Fruitport Community Schools
SPECIAL BOARD MEETING
Monday, May 9, 2022 – 5:00 p.m.
Board of Education Meeting Room
3255 E. Pontaluna Rd.
Fruitport, MI 49415

Athletic Field Change Order

BULLETIN NO. 1

DATE OF ISSUANCE: April 4, 2022
PROJECT: Athletic Improvements
OWNER: Fruitport Community Schools
ARCHITECT'S PROJECT NO.: 14-162.24
ORIGINAL BID ISSUE DATE: November 1, 2021

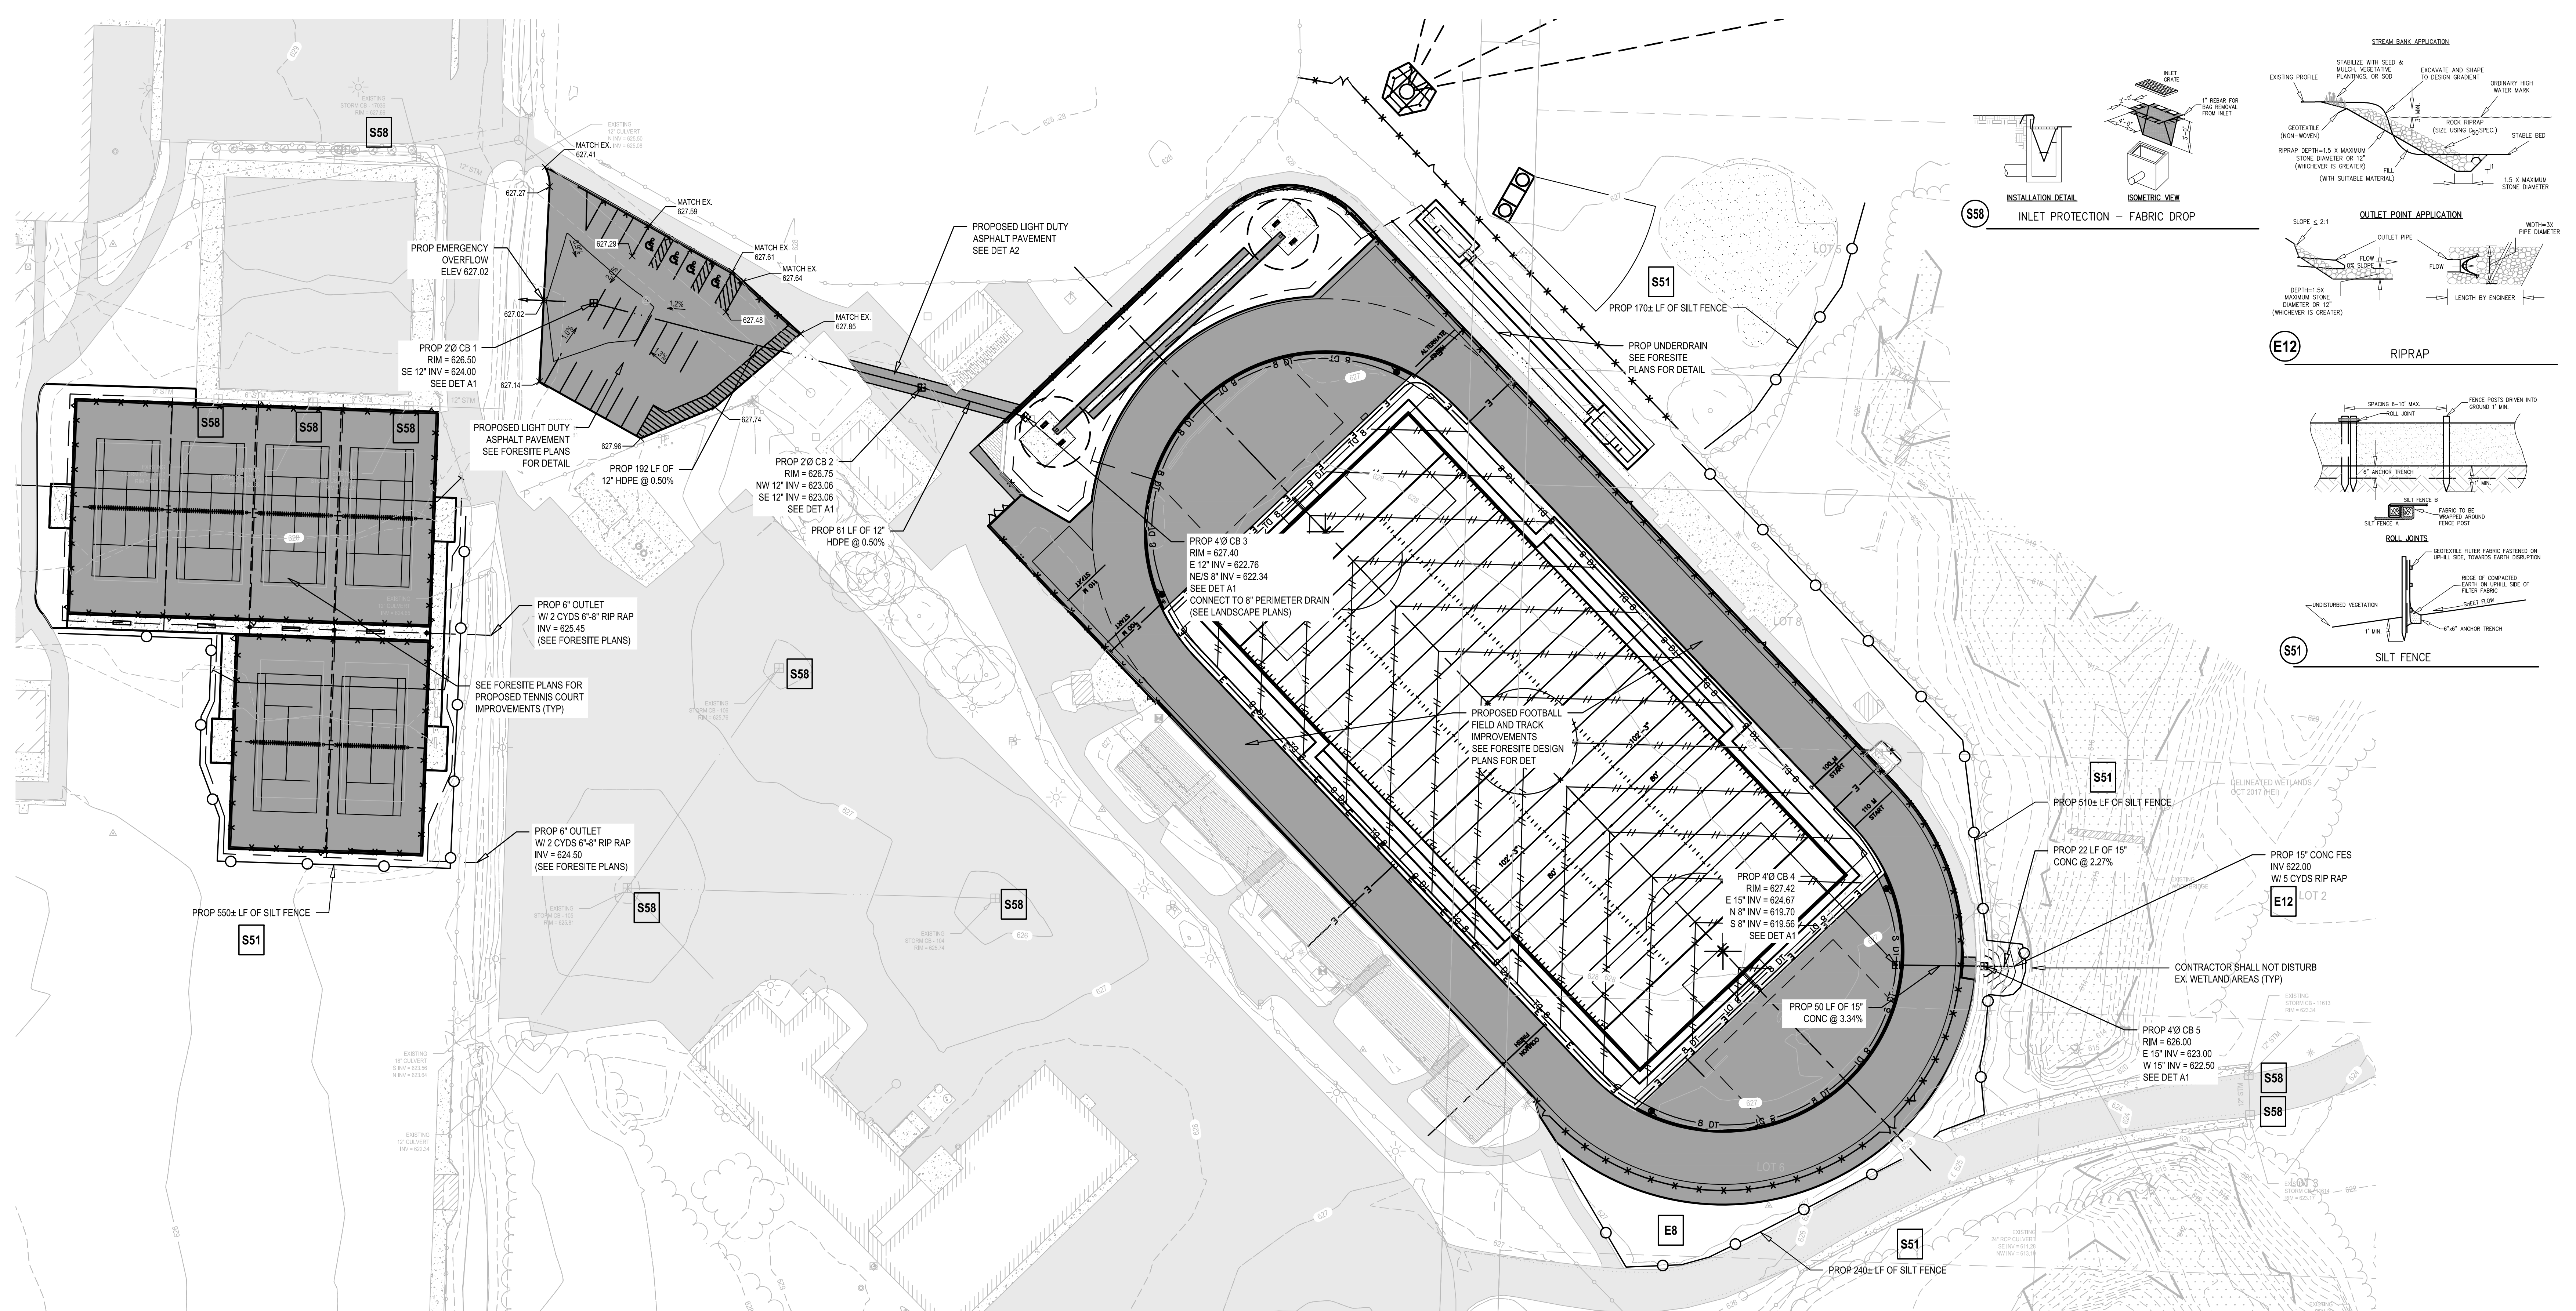
BUL-1 Item No. 12 - Grading & Storm Sewer Plan [Design Change]

Proposed parking area grading and storm sewer layout for improvements. Soil erosion and sedimentation control measures are also included on this sheet.
